System Impact Assessment Report

Project: *Windsor Area Transmission Reinforcement*

Applicant: Hydro One Networks Inc.

CAA ID 2008-318

Figure 6: Single Line Diagram of Leamington TS

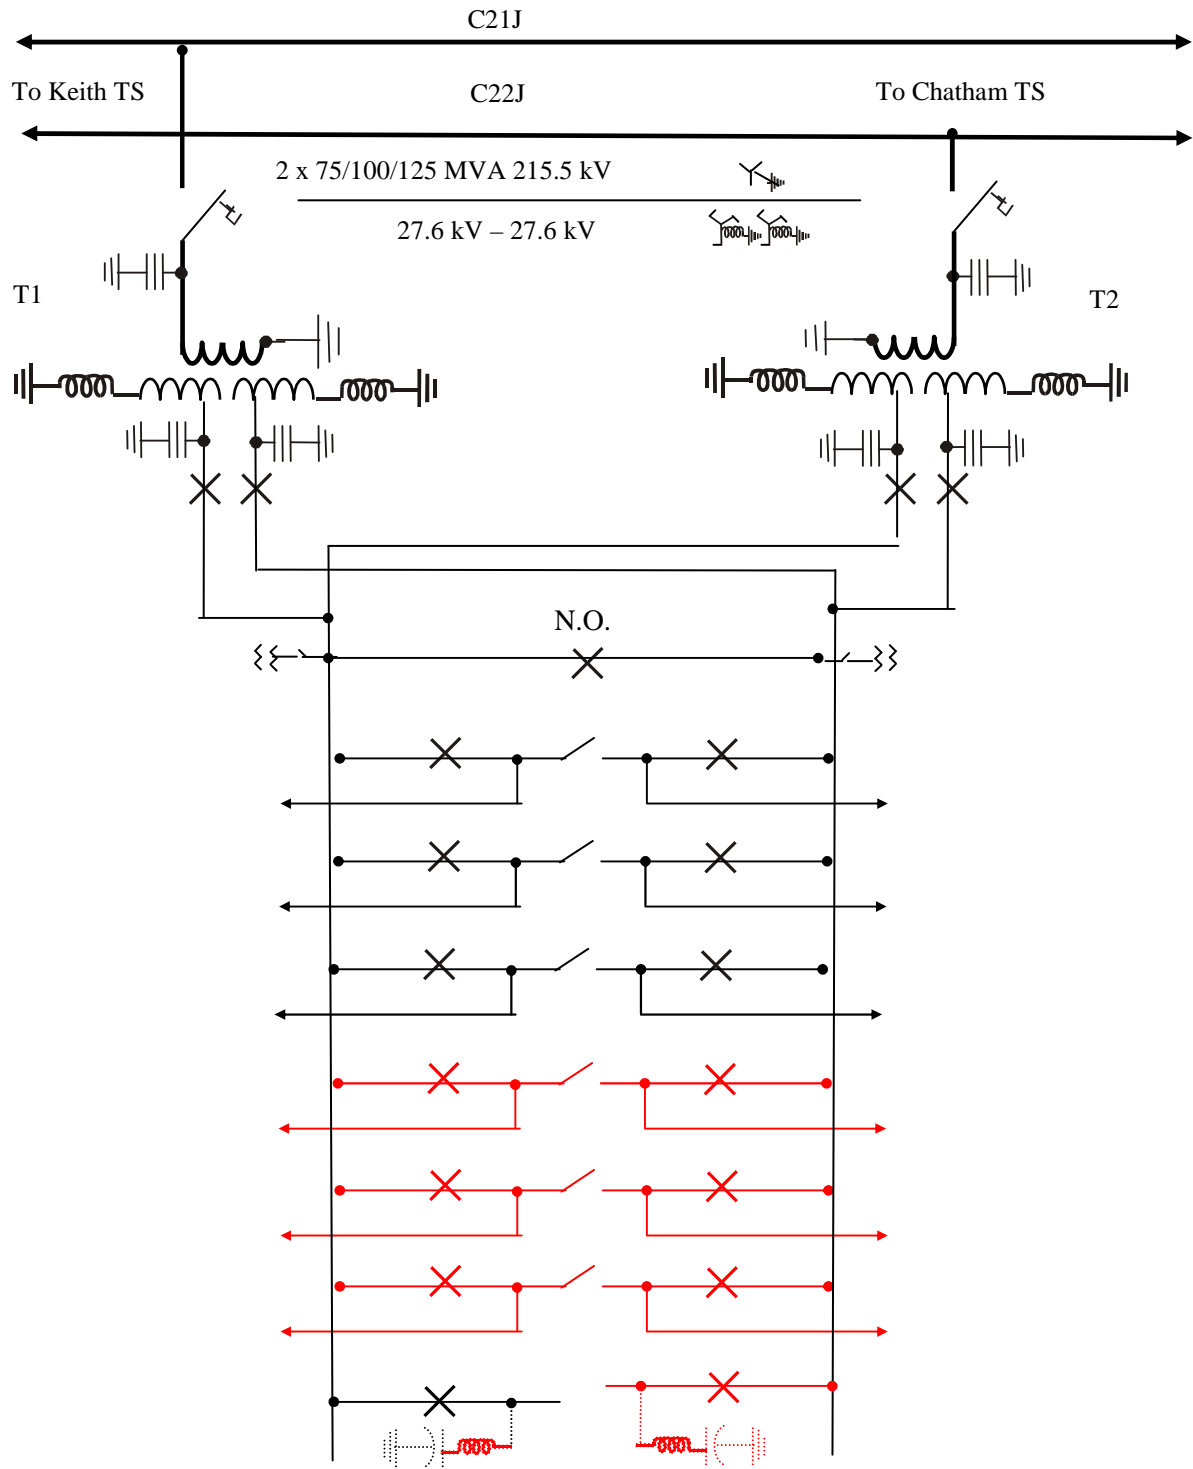
The diagram that was provided by the applicant shows each transformer being separated from the transmission system via a motorized disconnection switch. For this particular arrangement the Transmission System Code requires that transfer trip of the Transmitter's breakers at the terminal stations be provided for transformer faults or for a condition of failure to operate of the LT breakers. In the case of Leamington TS, which is to be connected to the double circuit 230 kV lines C21J/C22J the transfer trip must be sent to the Keith TS, Chatham TS and Lauzon TS terminals of the faulted circuit.

Figure 8: LV Power Factor at Kingsville TS on June 26 Before Compensation

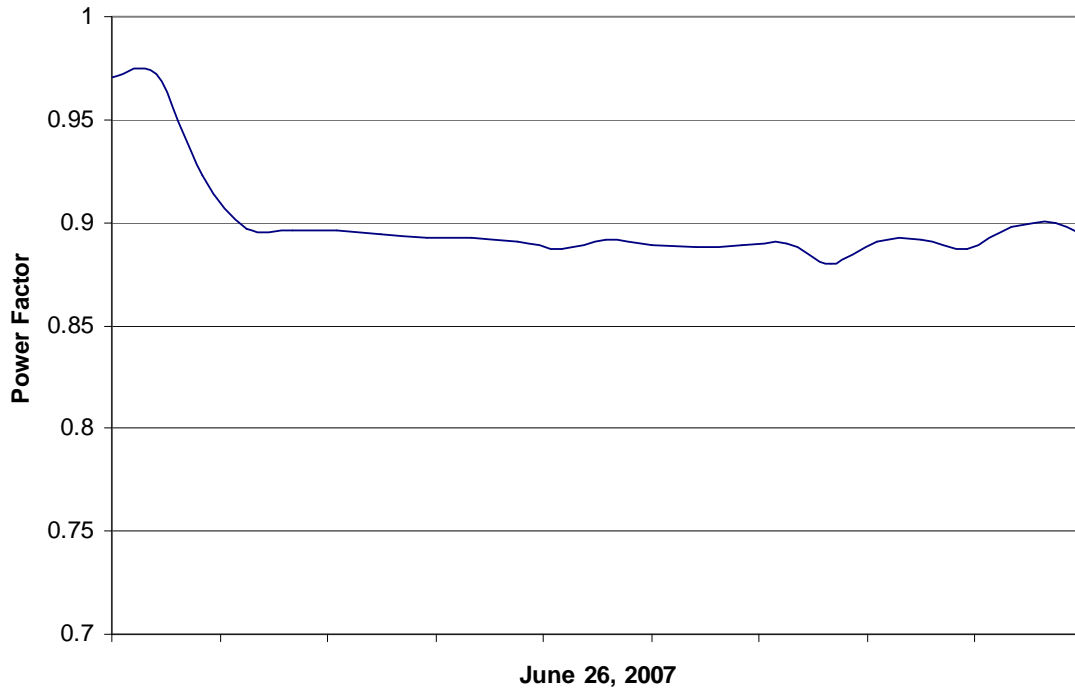
It can be seen that the load power factor was as low as 0.88. using this power factor for the load at Leamington TS it can be concluded that power factor correction equipment must be installed at the new station. Based on the load forecast for Leamington TS provided by Hydro One, further study was carried out to figure out the time schedule for the needed reactive compensation. The reactive power consumed by the transformers was estimated and the results are shown in Table 2 below.

Based on the load information at Kingsville the power factor at the defined metered point at Leamington TS will be below 0.9 lagging when the station is placed in service. As the load increases, additional reactive compensation will become necessary. Hydro One and the area LDC shall work together to initiate a plan for reactive load compensation at the station and/or customer side to ensure compliance with the Market Rules and to inform the IESO.

To meet the load power factor requirement at the new Leamington TS LV 10 MVAR shunt capacitors are required to be installed and available in 2012.
